CROSSROADS MIXED USE FILING NO. 2

GRADING & EROSION CONTROL PLANS

NOVEMBER 2022

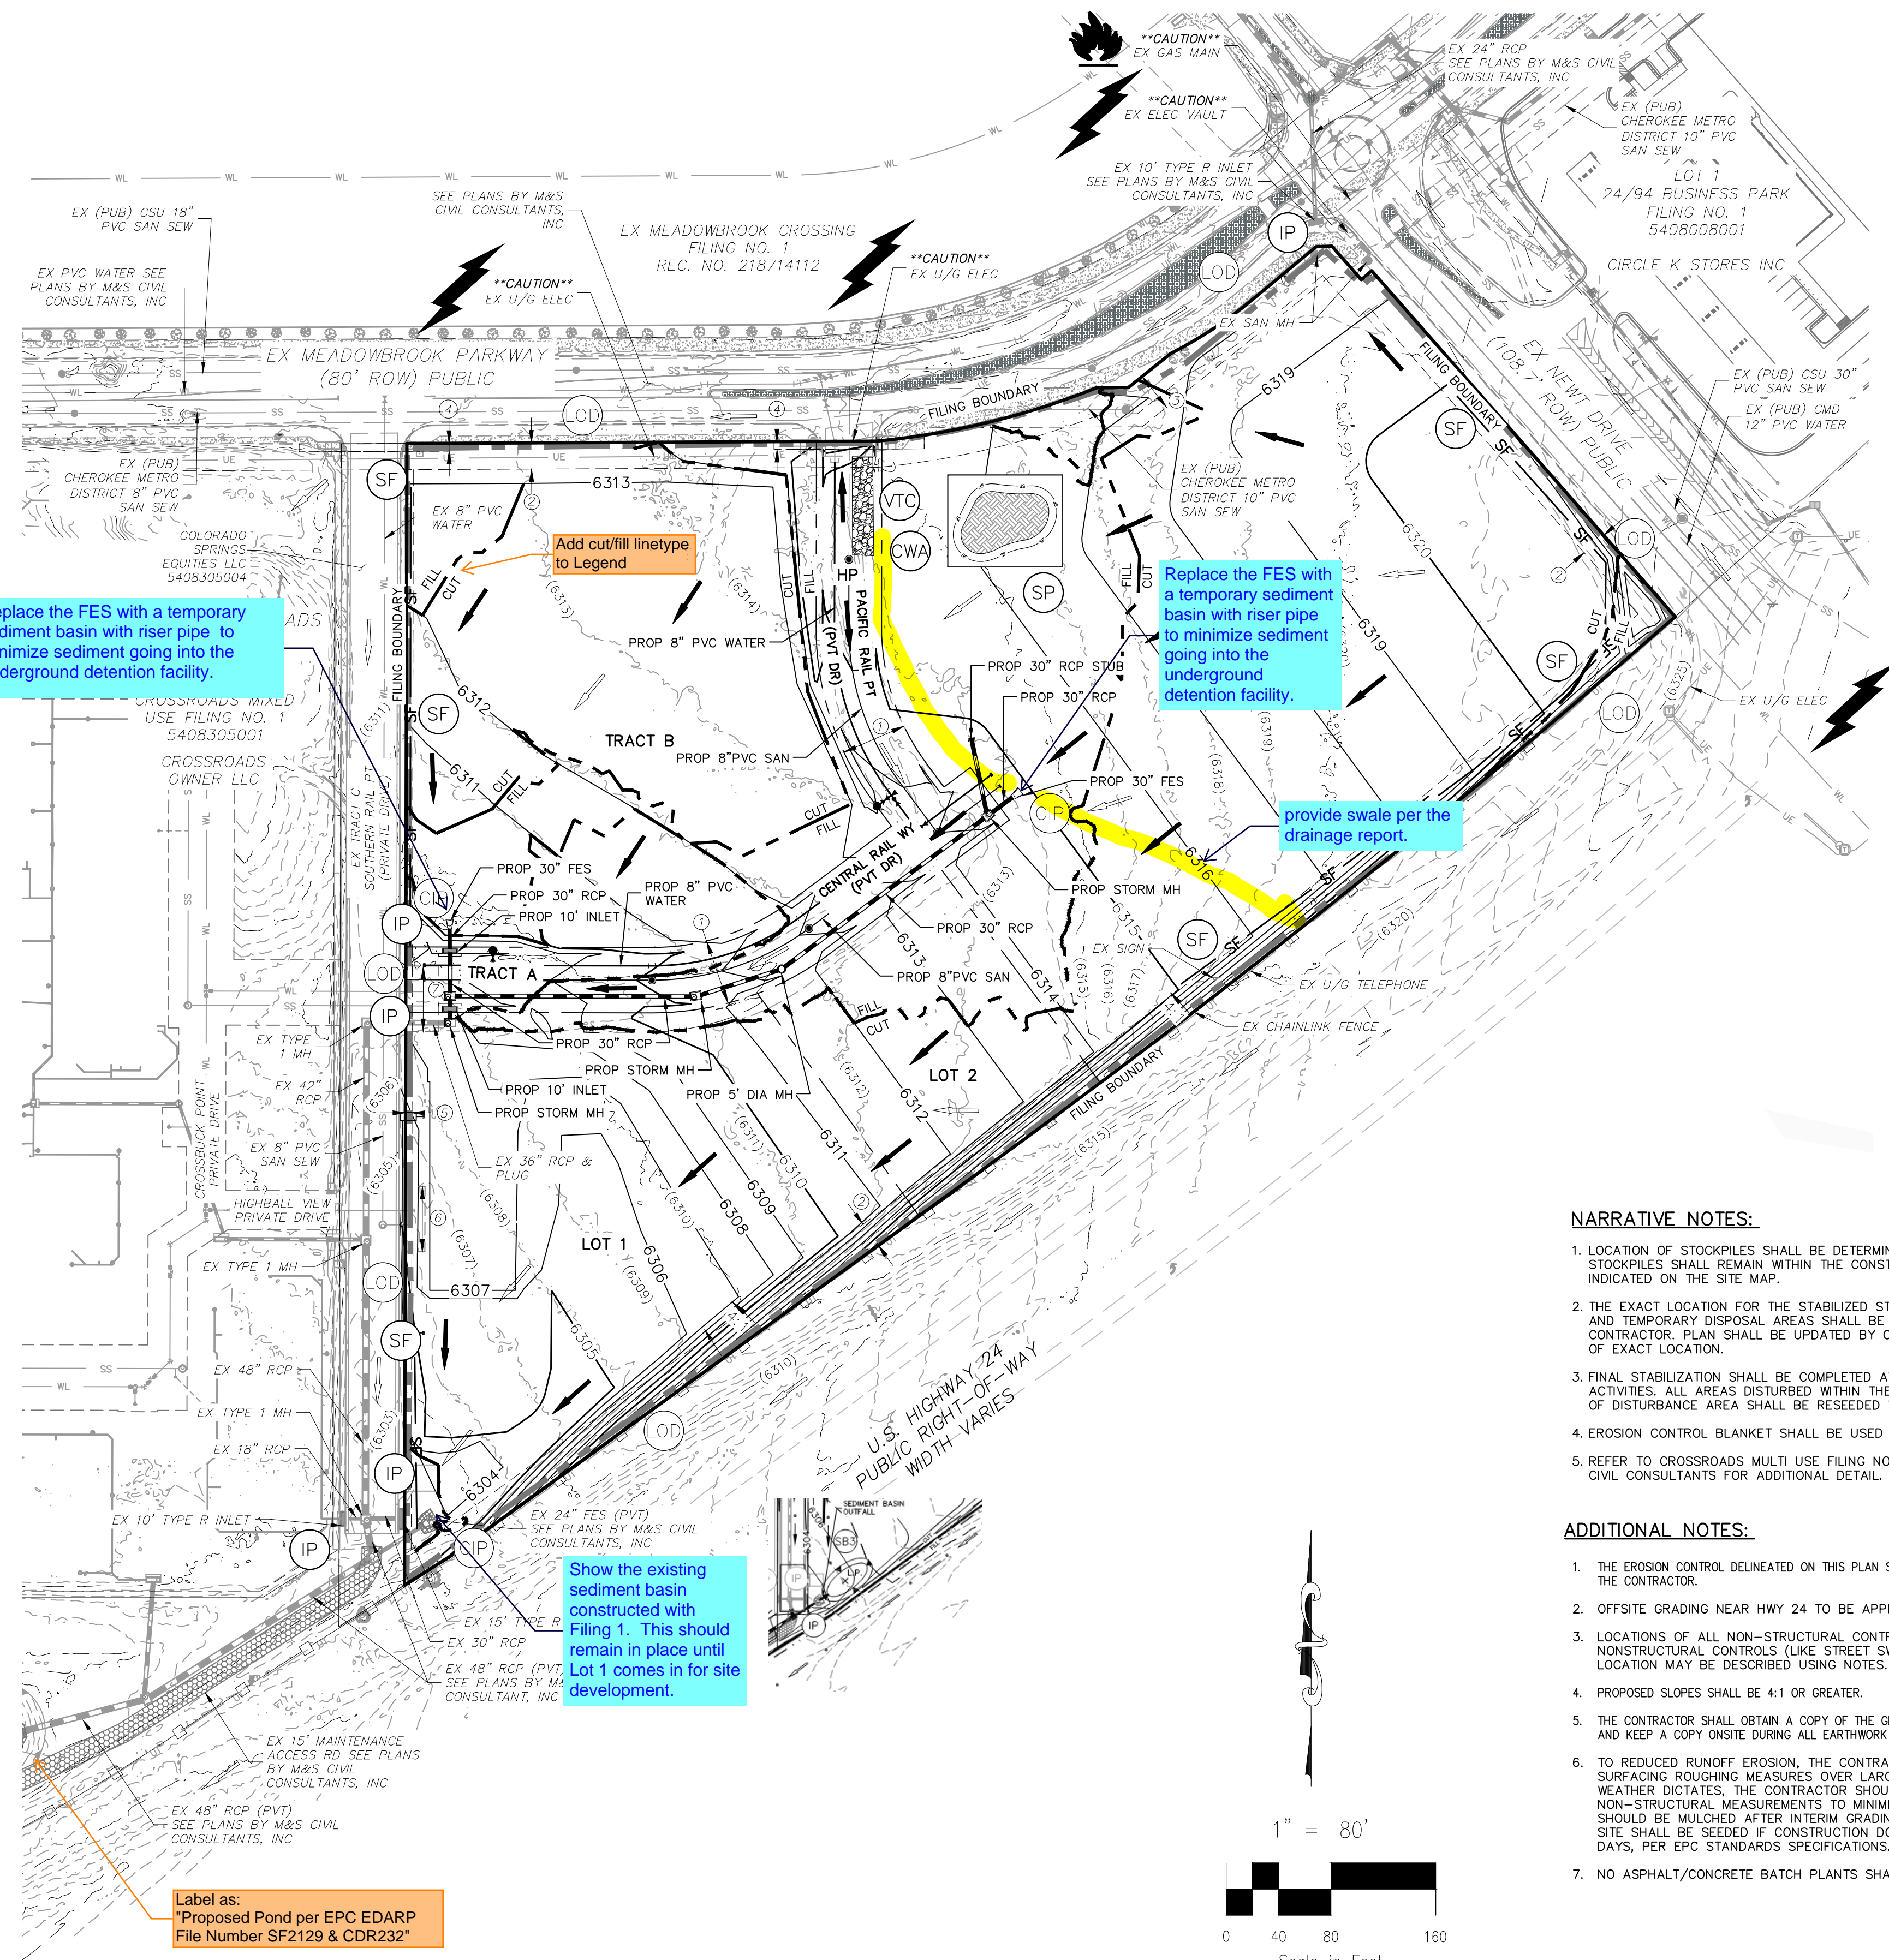
Revise to:
"EPC's EDARP File Number: SF2238"
(with no dashes or extras zeros or extra spaces in the file number)

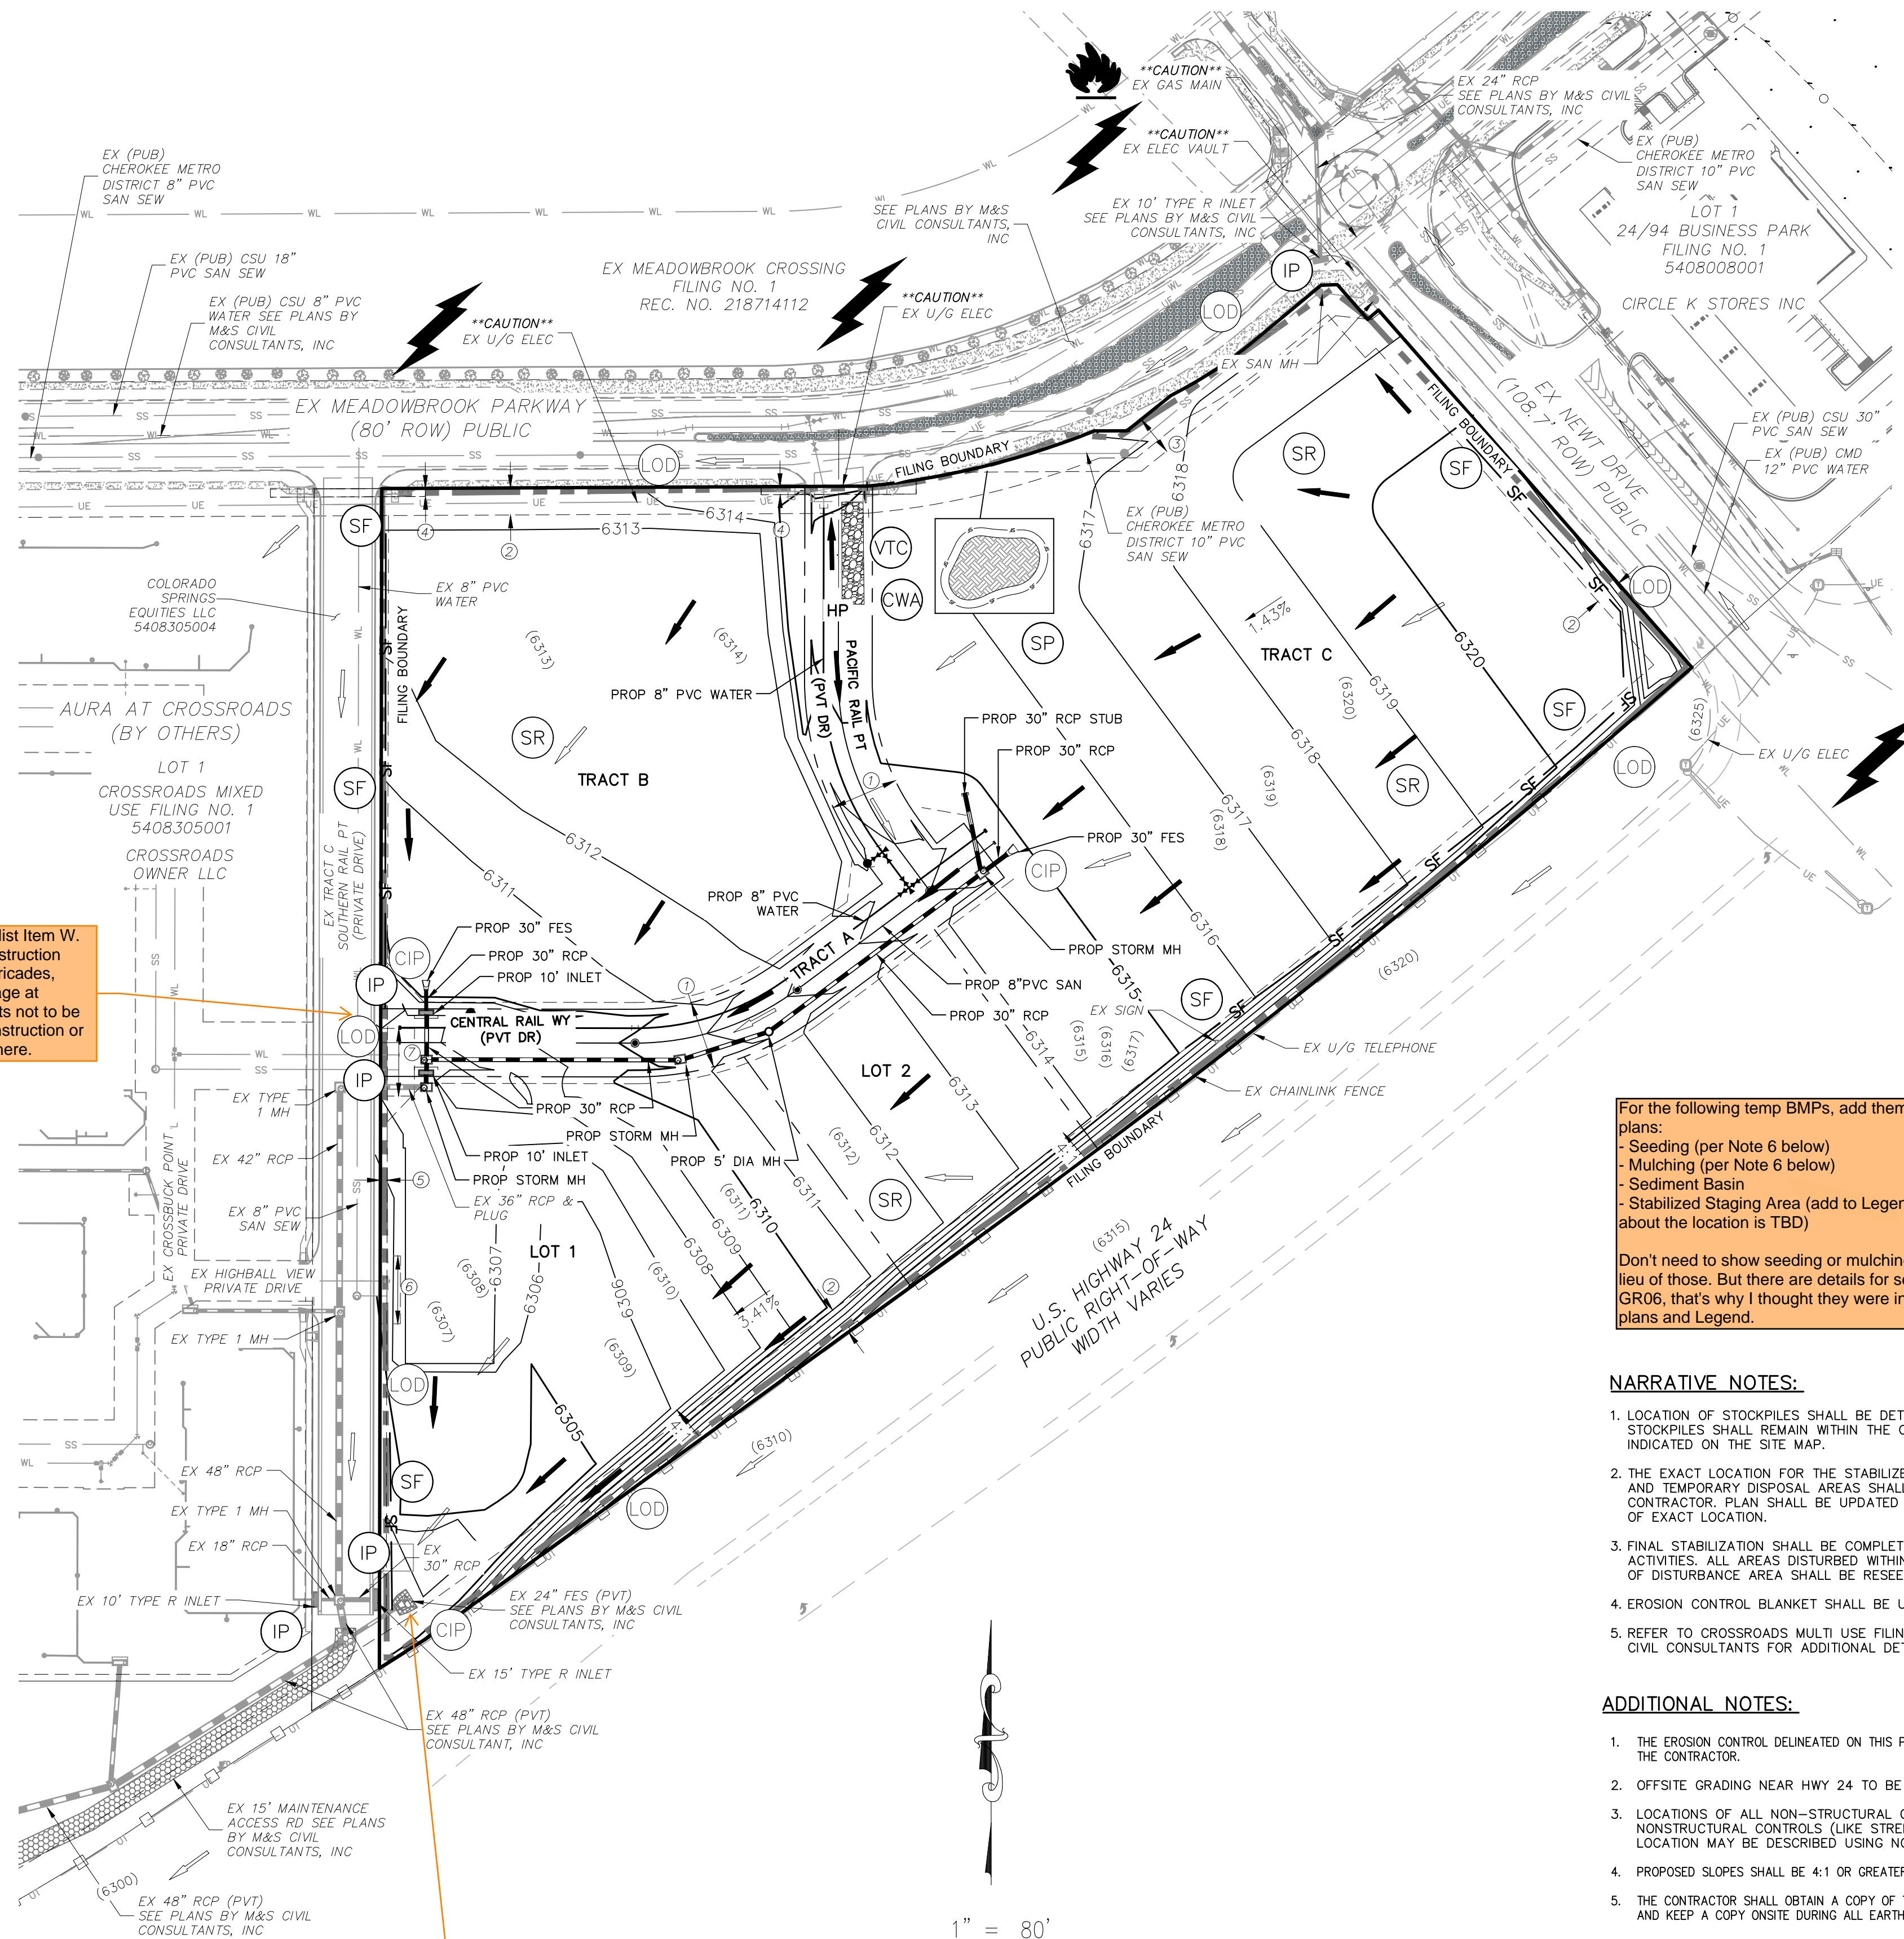
Replace the FES with a temporary sediment basin with riser pipe to minimize sediment going into the underground detention facility.

Show the existing sediment basin constructed with Filing 1. This should remain in place until Lot 1 comes in for site development.

Replace the FES with a temporary sediment basin with riser pipe to minimize sediment going into the underground detention facility.

provide swale per the drainage report.

Label as:
Proposed Pond per EPC EDARP
File Number SF2129 & CDR232"

GEC Checklist Item W.
Provide construction fencing, barricades, and/or signage at access points not to be used for construction or add a VTC here.

I also made this comment below on the plans for CDR232, but it applies to this site as well:
Having sufficient BMPs upstream of the pond (like inlet protection) will be crucial to keeping the UGD system from getting inundated with sediment once the UGD system is installed but the tributary basins are still being developed and without sufficient vegetation. This is more important for UGD systems than above ground ponds, because it is more difficult to get sediment out of UGD systems. Especially if a bigger storm occurs during construction that causes untreated runoff to bypass the isolator rows via the manifold, as there is no easy way to remove sediment from the non-isolator rows.
Also, because the system is now below ground, a TSB is not likely to go in before it like would occur if there was going to be an above ground pond. So look at putting a couple smaller TSBs at inlet points.
